Access Compliance Report

Public Rights-of-Way

(Curb Ramps)

Intersection ID: 23288	Main Street: ALEXANDER_RD	Cross Street: SHAFTESBURY_RD	Location: SW
ADA ID: 2C511603511F	Ramp Type: Perp	Initial Pass/Fail: Pass	Overall Compliance: No
Severity Score: 10			
Codes/Mitigation Info/Possible Solution		Field Measurements/Component Compliance

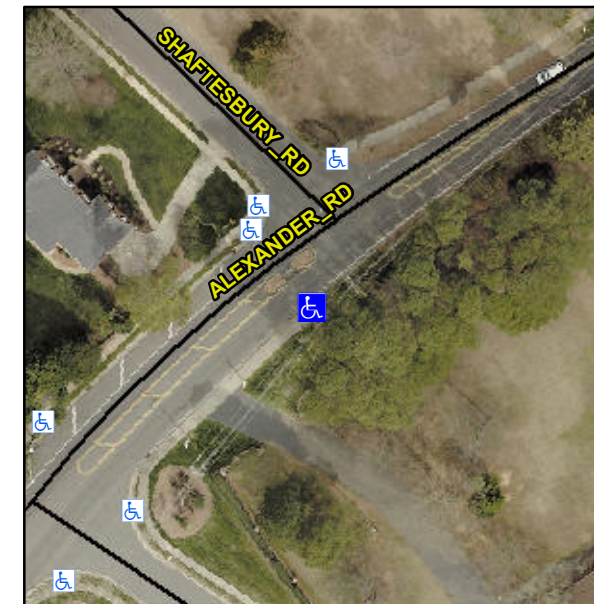
R304.2.1, R304.2.2-Perp, R304.3.2-Para, R304.5.3, R305.2

Compliance	Description	Data	Compliance	Description	Data
N/A	Ramp Length (in)	71.0	Yes	Ramp Slope (%)	5.3
Yes	Ramp Width (in)	48.0	Yes	Ramp XSlope (%)	1.1
N/A	Flare Type LT	None	N/A	Flare Type RT	N/A
N/A	Flare Slope LT (%)	N/A	Yes	Flare Slope RT (%)	4.9
N/A	Flare Traversable LT?	N/A	N/A	Flare Traversable RT?	Yes
No	Landing Length (in)	N/A	Yes	DWS Provided?	Yes
No	Landing Width (in)	N/A	Yes	DWS Contrast?	Yes
No	Landing Slope (%)	N/A	Yes	DWS Length (in)	24.5
No	Landing X Slope (%)	N/A	Yes	DWS Full Width?	Yes
N/A	Landing Curb? (Y/N)	No	No	DWS Offset (in)	4.5
N/A	Shared Landing?	No			
Yes	Gutter Ponding?	No	Yes	Gutter Slope (%)	3.4
Yes	Gutter Lip Ht (in)	0.0	Yes	Gutter X Slope (%)	0.1
N/A	Painted X Walk1?	No	N/A	Painted X Walk2?	N/A
	X Walk 1 Direction	To NW		X Walk 2 Direction	N/A
N/A	X Walk 1 Width (in)	N/A	N/A	X Walk 2 Width (in)	N/A
	X Walk 1 Slope (%)	6.3		X Walk 2 Slope (%)	N/A
	X Walk 1 X Slope (%)	1.1		X Walk 2 X Slope (%)	N/A

Remove & Replace Entire Ramp.
